November 22, 2002
02-10NRC.DOC
MFN 02-091

**Subject: Reportable Condition Stability Option III: Period Based Algorithm
 T_{min} Specification**

**Reference: NEDO-31960-A, BWR Owners' Group Long-Term Stability Solutions
Licensing Methodology (Supplement 1), November 1995**

Attachment 1 - Figure 1. Expected Oscillation Period vs. Core Flow

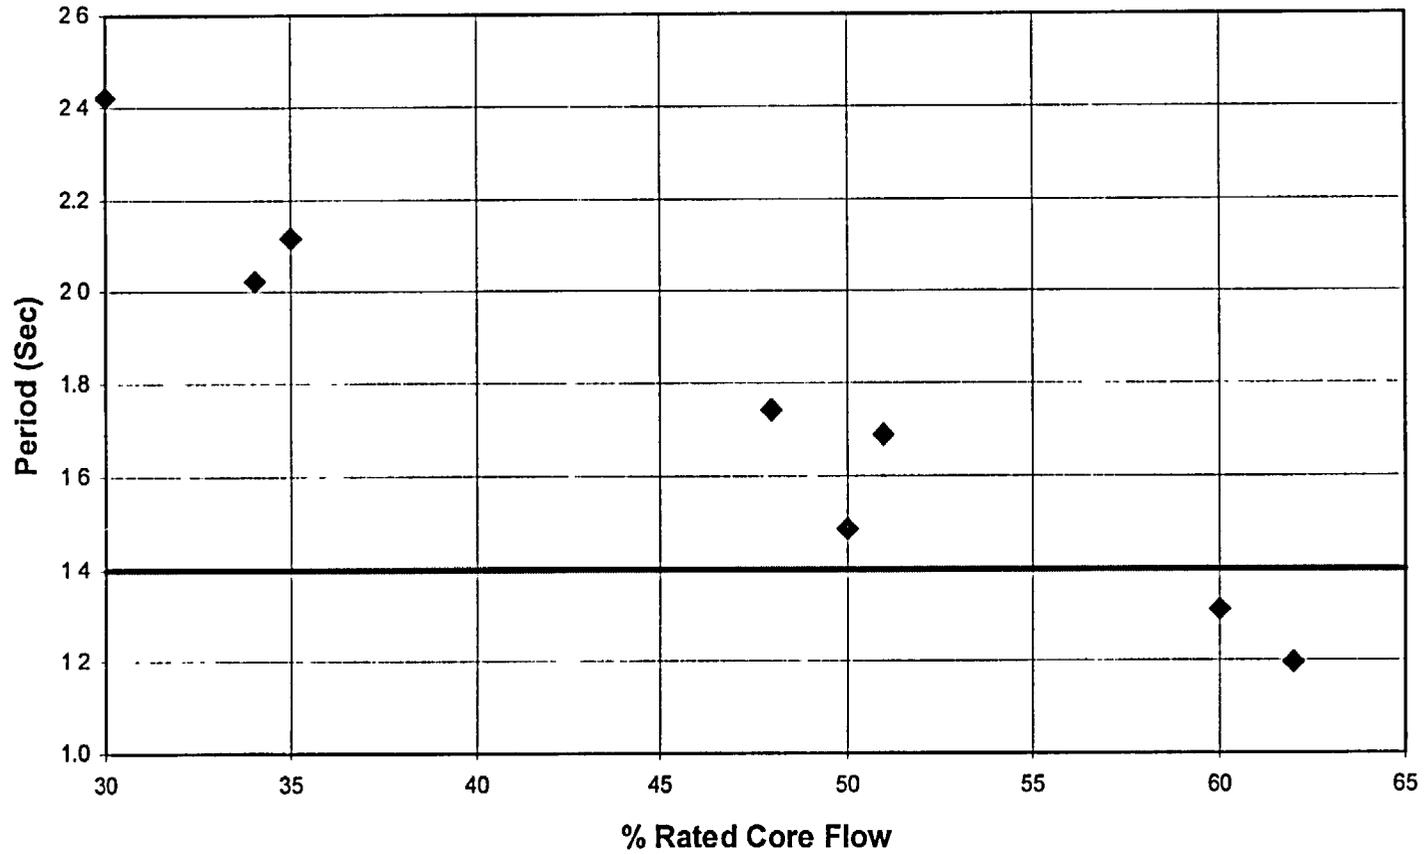
GE has performed calculations of oscillation period for different power/flow conditions with the GE frequency domain code ODYSY. Representative results from these calculations are shown in Figure 1 (attached). Calculations with other models and plant experience support these results.

The lowest value specified in the "typical" range for T_{max} is 3.0 seconds. The results in Figure 1 show that all periods are less than 3.0 seconds and that there is a significant margin between the nominal calculated periods to the 3.0 seconds value. Therefore, even if a plant uses the lowest "typical" value for T_{max} , it is expected to be greater than the actual period. Therefore, the "typical" range specified in T_{max} causes no safety concern.

The highest value in the specified allowable range for T_{min} is 1.4 seconds. The results in Figure 1 show that at high core flow, the expected oscillation period is below 1.4 seconds. The margin to T_{min} of 1.4 second is not adequate since the use of this "typical" T_{min} value could lead to failure of the PBDA to detect an expected oscillation. Failure of automatic detection at this condition is not expected to result in fuel failures, but may lead to violation of the Technical Specification MCPR safety limit. This is considered to be a Reportable Condition on NEDO-31960-A, Supplement 1. GE analysis shows that for current licensed operation conditions, a generic T_{min} value of 1.2 seconds provides adequate margin to expected oscillation periods.

- 1) Absent plant-specific justification of a higher value, the OPRM is not considered to be operable with a T_{\min} value greater than 1.2 seconds; T_{\min} should be set to 1.2 seconds or lower. With T_{\min} set to 1.2 seconds or lower, the OPRM is considered to be operable. However, GE recommends that plants consider using a value of 1.0 second to provide additional margin to the expected period range.
- 2) The OPRM is considered operable for values of T_{\max} set to 3.0 seconds or higher. However, absent plant-specific justification, GE recommends using a T_{\max} value of 3.5 seconds or higher to provide additional margin to the expected period range.
- 3) A tighter T_{\min}/T_{\max} range may be justified based on plant-specific analysis and/or experience.

1. Absent plant-specific justification of a higher value, T_{\min} should be set to 1.2 seconds or lower. GE recommends that plants consider using a value of 1.0 second to provide additional margin to the expected period range.
